FALL MOUNTAIN FARM DEVELOPMENT PHOTOMETRIC SITE PLAN

ELECTRICAL PHOTOMETRIC SITE PLAN

Lighting Plan_V1.pdf Markup Summary

ELECTRICAL PHOTOMETRIC SITE PLAN

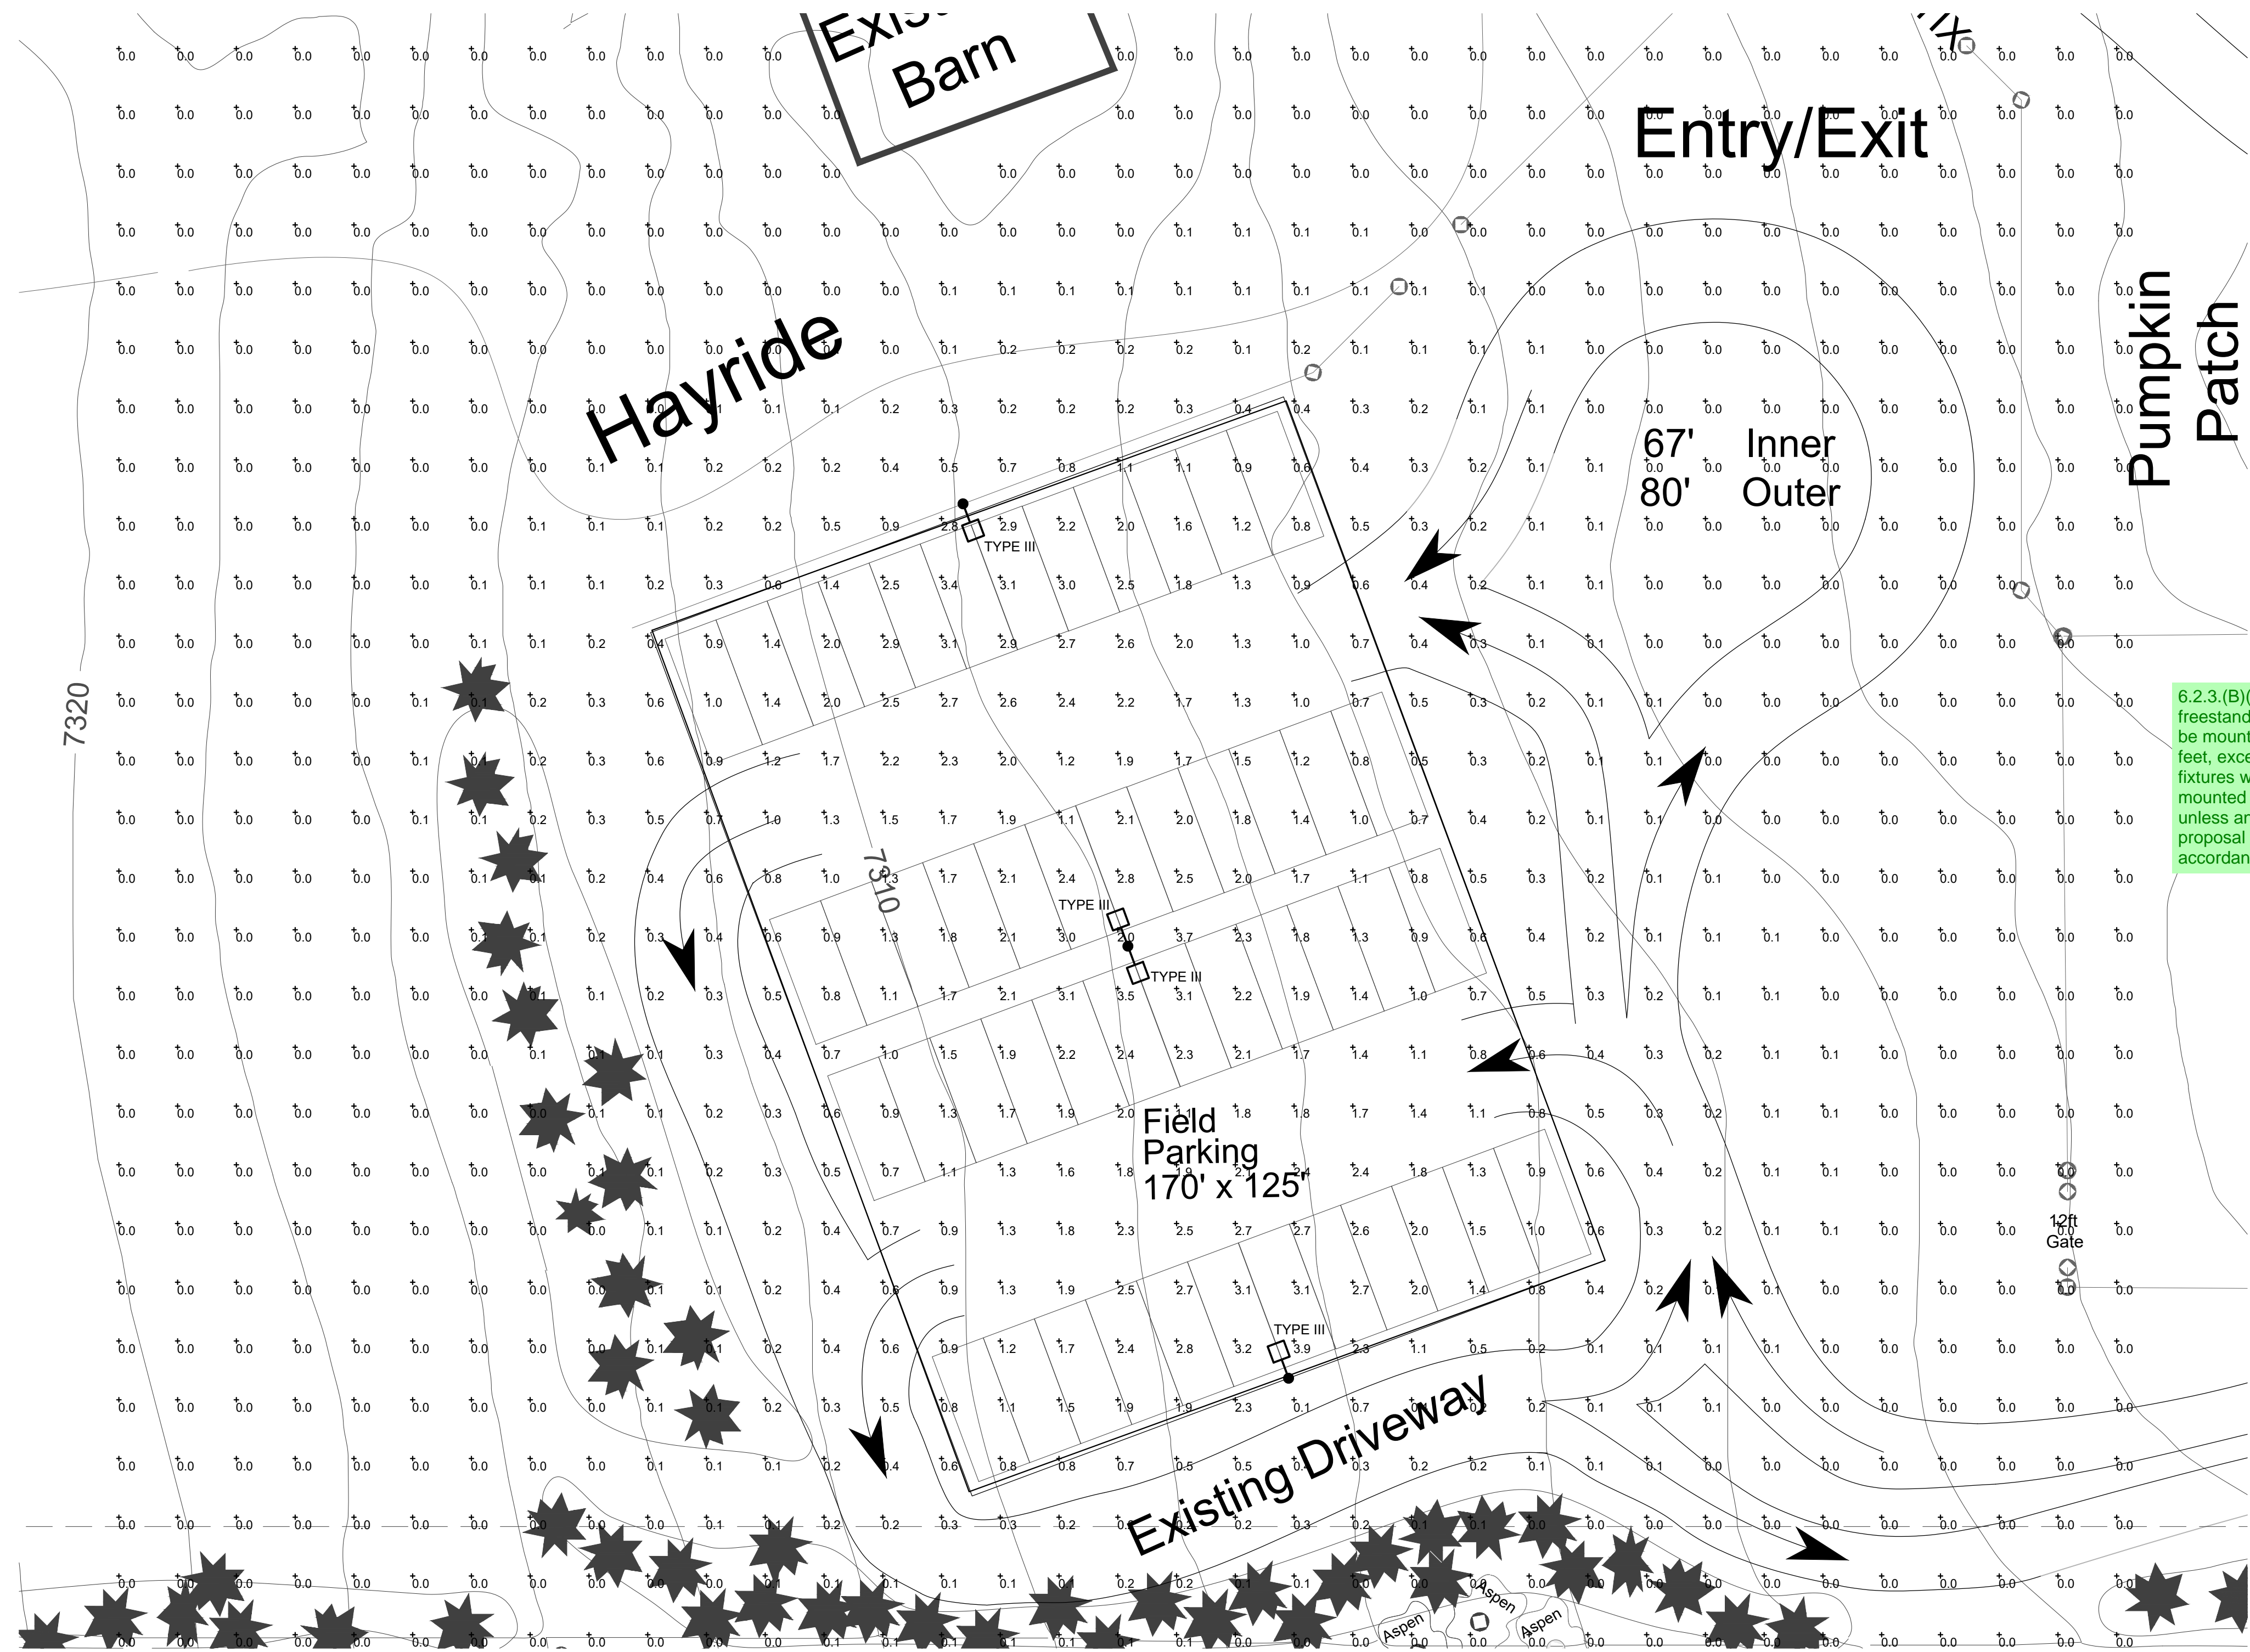
Please add to the plan:

Owner/Applicant name and contact phone # & email.

Plan preparer name & contact phone #

Show the location and height of all existing and proposed illuminating devices, including but not limited to, all parking area lights and external structural lights for all three parcels.

Photometric plan depicting the lighting levels (foot candles) throughout the property, at property lines, and along any adjacent rights-of-way.

Show location of all existing and proposed easements

6.2.3.(B)(2)Height. No freestanding light fixtures shall be mounted higher than 15 feet, except parking lot light fixtures which shall be mounted no higher than 20 feet unless an alternative lighting proposal is approved in accordance with this Code.

- Please add to the plan:
- Owner/Applicant name and contact phone # & email.
- Plan preparer name & contact phone #
- Show the location and height of all existing and proposed illuminating devices, including but not limited to, all parking area lights and external structural lights for all three parcels.
- Photometric plan depicting the lighting levels (foot candles) throughout the property, at property lines, and along any adjacent rights-of-way.
- Show location of all existing and proposed easements
